## DMMP Evaluation of Potential Dredge Sediments in the Kenmore Navigation Channel and Surrounding Areas

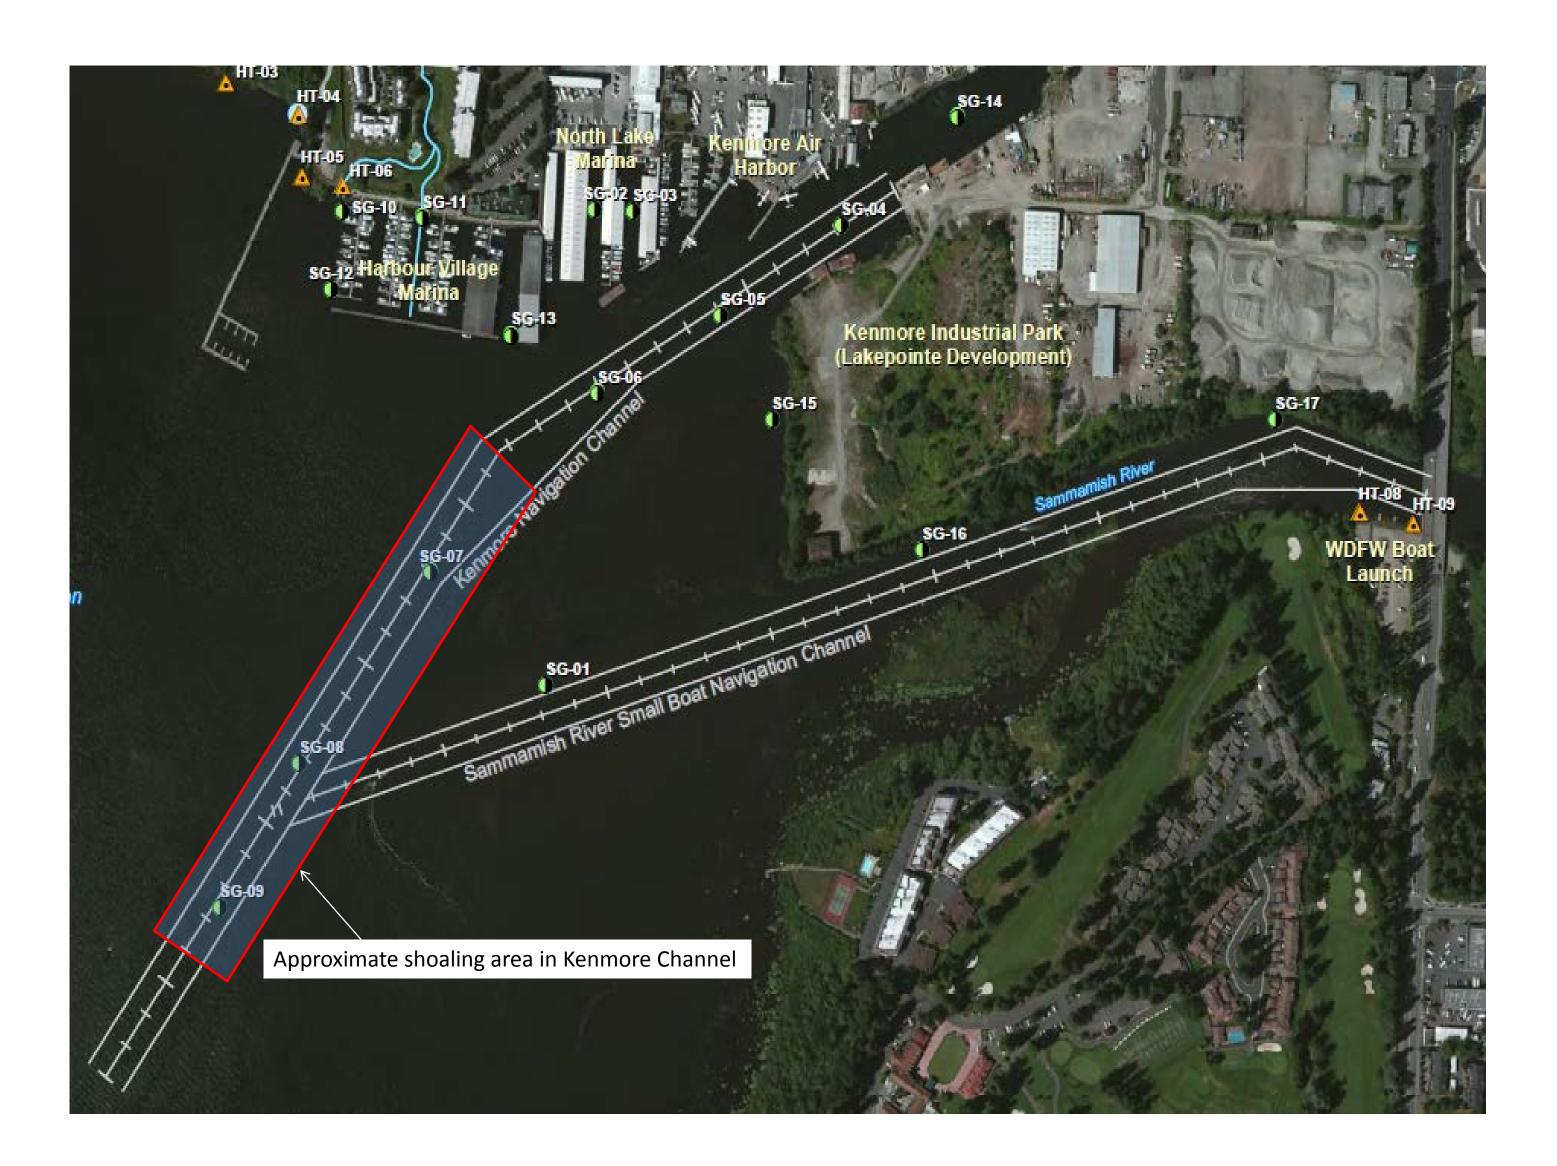
- The DMMP evaluation for Harbour Village Marina was completed previously; data from this study indicates that dioxin is still elevated in the top 10 cm (as opposed to the full dredge prism evaluated previously), although concentrations appear to be lower in the more recently deposited sediments.

- In this sampling event, only the more recently deposited sediments (top 10 to 27 cm) were evaluated in this sampling event. Since this material does not represent the entire dredge prism or the surface exposed by dredging, the DMMP cannot use the data for determining suitability for open water disposal or for antidegradation evaluation.

- This data does indicate that material will need further sampling to support dredging of the Kenmore Navigational Channel and Northlake Marina. Deeper sediments and "Z-layer" samples representing surface exposed by dredging must be characterized prior to dredging the material.

- Comparison to DMMP marine open-water values would be used to evaluate material for open water disposal. At the PSSDA marine open-water disposal sites.

- Comparison to the RSET FW values would be used for in-water re-use in freshwater bodies, and for antidegradation evaluation. Since the release of the Screening Level Evaluation, Ecology has promulgated new freshwater criteria for protection of benthic invertebrate communities, which become effective in Sept 2013. The DMMP and RSET agencies are currently working on adopting these values along with "overlays" for protection of other species. Please see the Ecology presentations for comparison of the data to the new freshwater criteria.
